DELAURENTIS - VACANT LOT - 21 NETHERMONT AVE
NEW HOUSE CONSTRUCTION - TAX ID: SECTION 122.16-BLOCK 4- LOT 41

Re: 21 Nethermont Ave - Section, Block & Lot: 122.16/4/41 – Response to Comments Dated 03/18/2021

Below are responses to the questions/comments from 03/18/2021:

SCALE: AS SHOWN
	DATE: APRIL 01, 2021
DRAWN BY: GC	CHECKED BY: ES.
SD-1

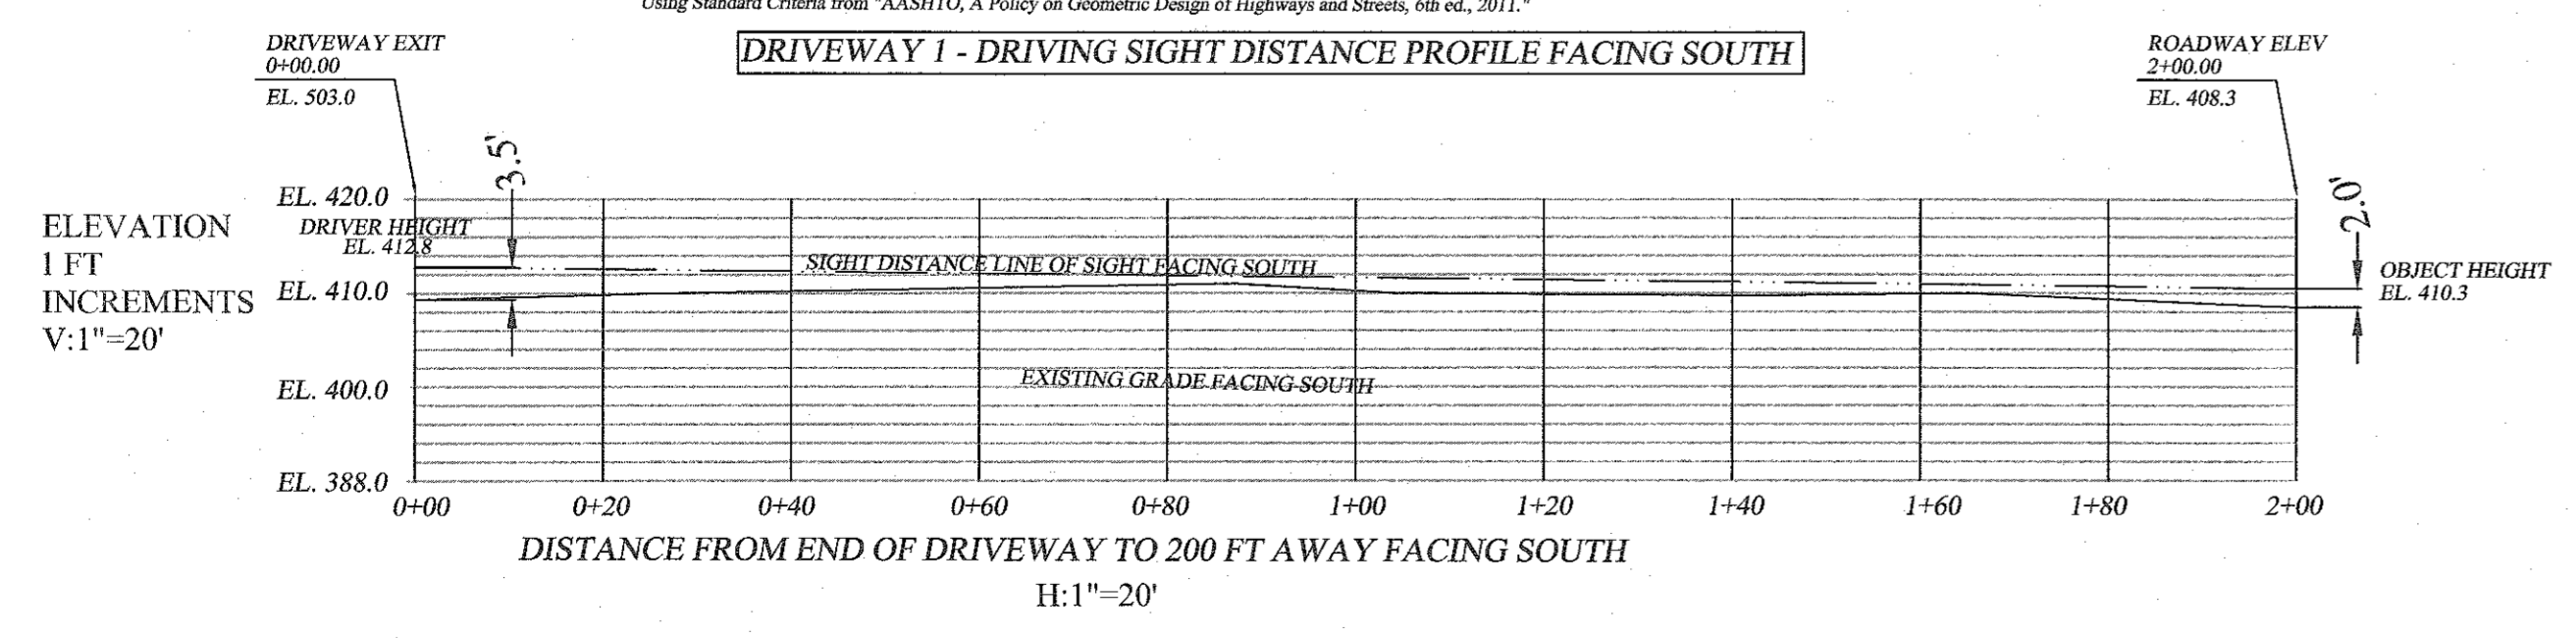
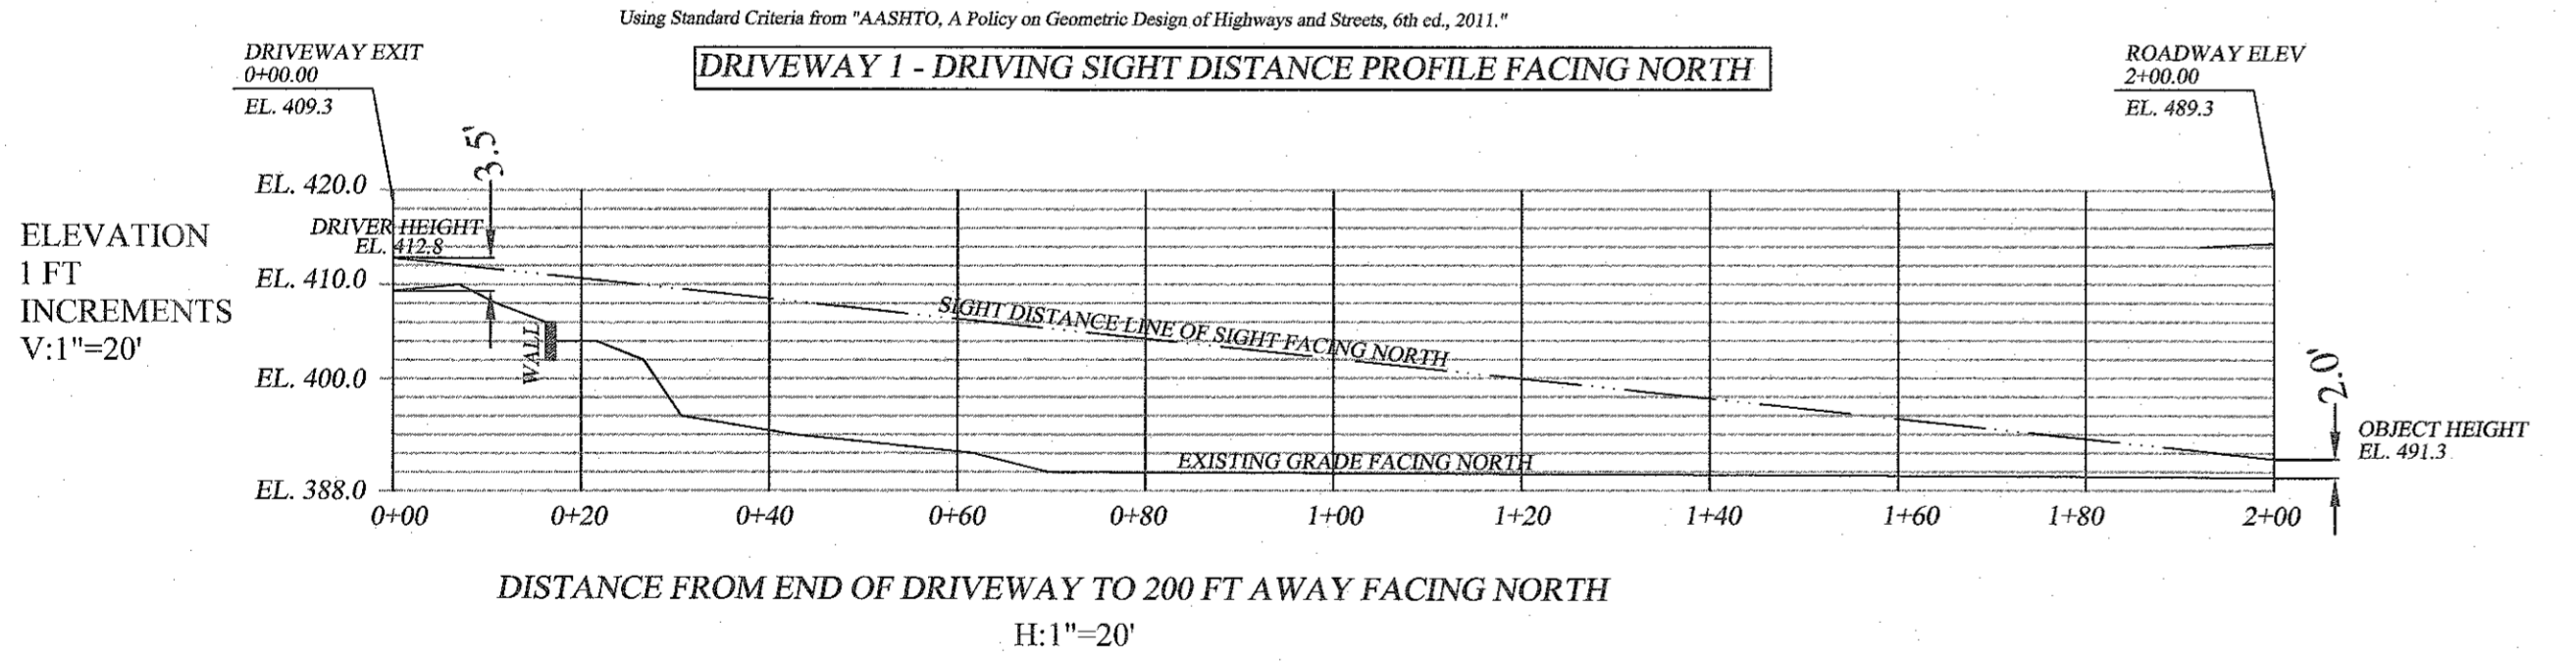
- **Max wall height Calculations will be provided once a final design concept is accepted.**
8. As previously requested, sight distance profiles have been provided, however, they shall be corrected to illustrate adequate sight distance for a minimum of 200 feet in each direction. It is difficult to verify compliance based on the imagery provided. We would suggest importing the GIS topography and planimetric data to generate the profile as opposed to working from an image. The sight profile shall establish the driver's eye set 3.5 feet above grade, 14 feet back from the edge of the road with a line of sight to an object in the road 2 feet above grade. The elevations shall use the same datum as the submitted plans and correspond to the grades in the profiles.

- **Revised sight distance calculations have been provided for both driveway designs.**
9. This office is concerned with the apparent lack of adequate sight lines from the driveway as proposed. The topography and alignment of the existing road and the dense vegetation on adjacent properties will appear to hinder safe lines of sight in either direction. It appears that the plan will require significant removal of existing vegetation to provide the necessary sight distance, much of which is on adjacent properties or within the right-of-way and will require agreement by the neighbors and sight line easements. As previously recommend, the applicant should prepare an alternate plan for the Planning Board's consideration illustrating the driveway access from the southside of the property toward the crest of the hill on Nethermont Avenue. We would recommend evaluating a driveway
